Re: Bid # 08ITB59460K-DJ W032 Pritchard Mountain Elevated Water Tank

ADDENDUM No. 1

STAKING PLAN C3.0

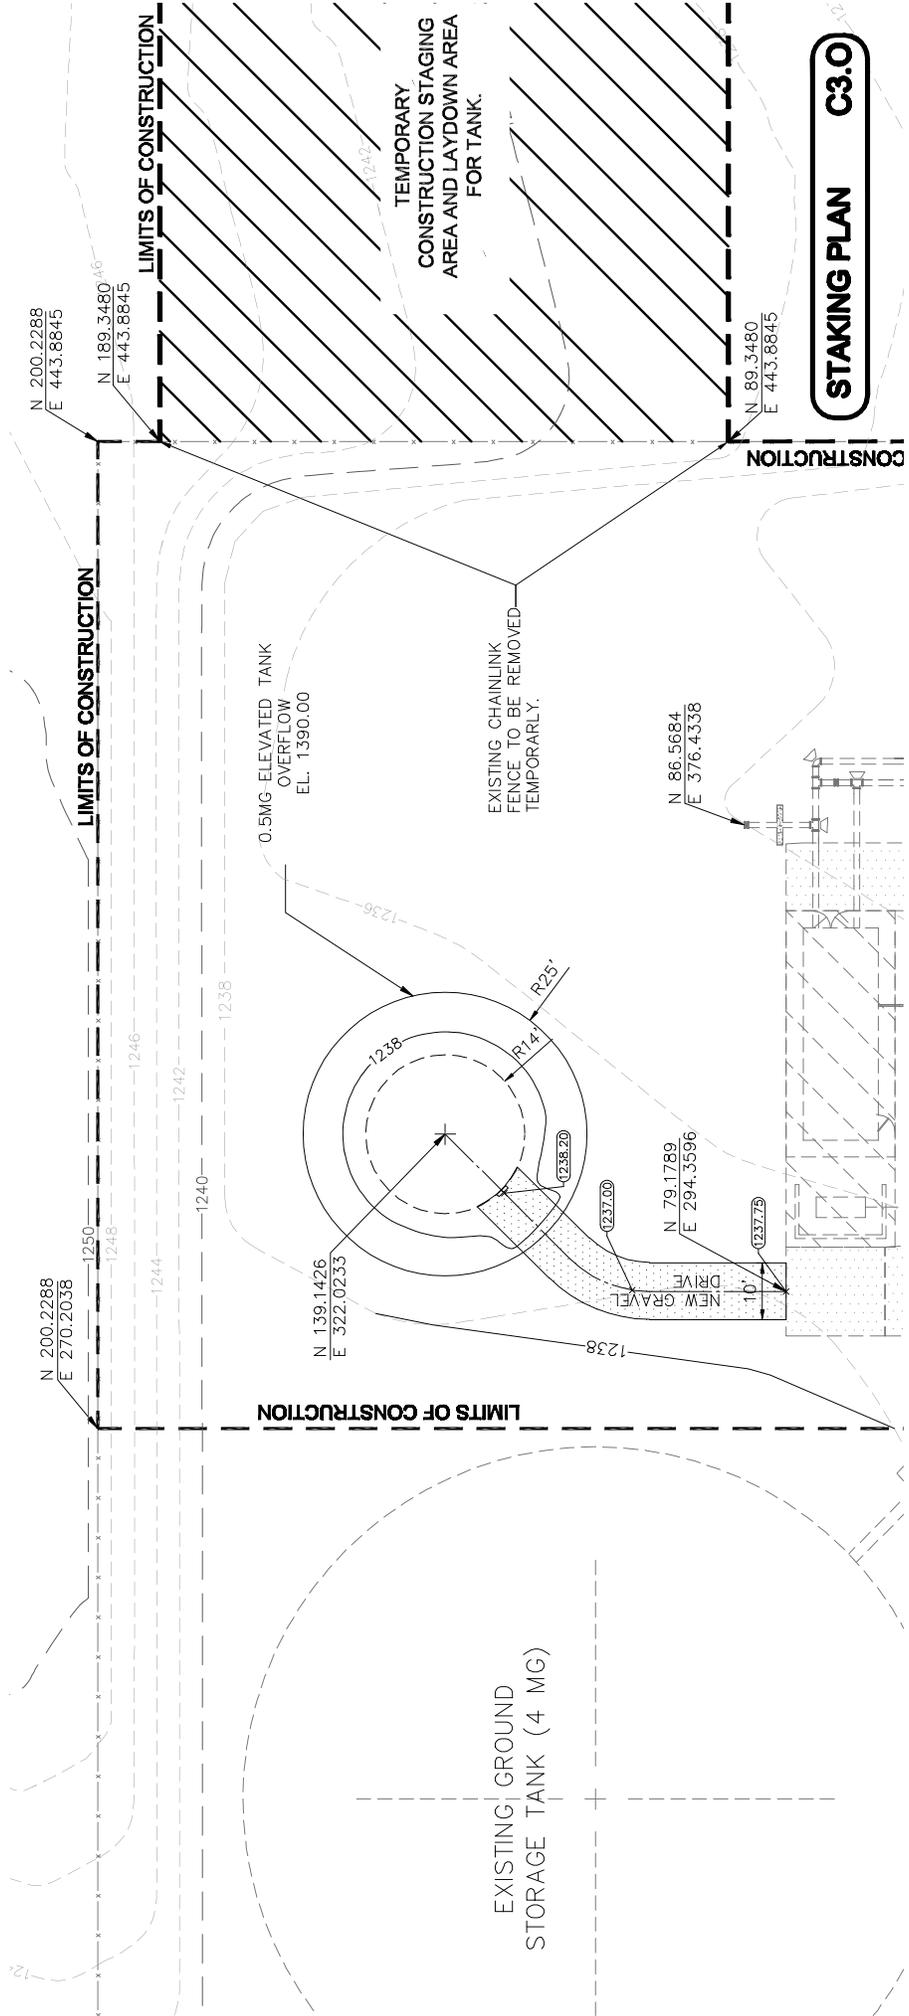
- Item 1 Sheet C3.0 Staking Plan, replace a portion of the site plan with the revised site plan portion on the attached sketch labeled "Staking Plan C3.0". This sketch revises the driveway alignment.
- Item 2 Sheet C5.0 Utility Plan, top left, replace a portion of the site plan with the revised site plan portion on the attached sketch labeled "Utility Plan C5.0". This sketch revises the routing of the 16" DIP drain and overflow pipe to the ditch on the left rather than going across Freemanville Road. This sketch also revises the driveway alignment.
- Item 3 Sheet C5.0 Utility Plan, bottom of sheet, delete the 16" DIP drain and overflow profile. Also delete Section A-A on the right side of the page.
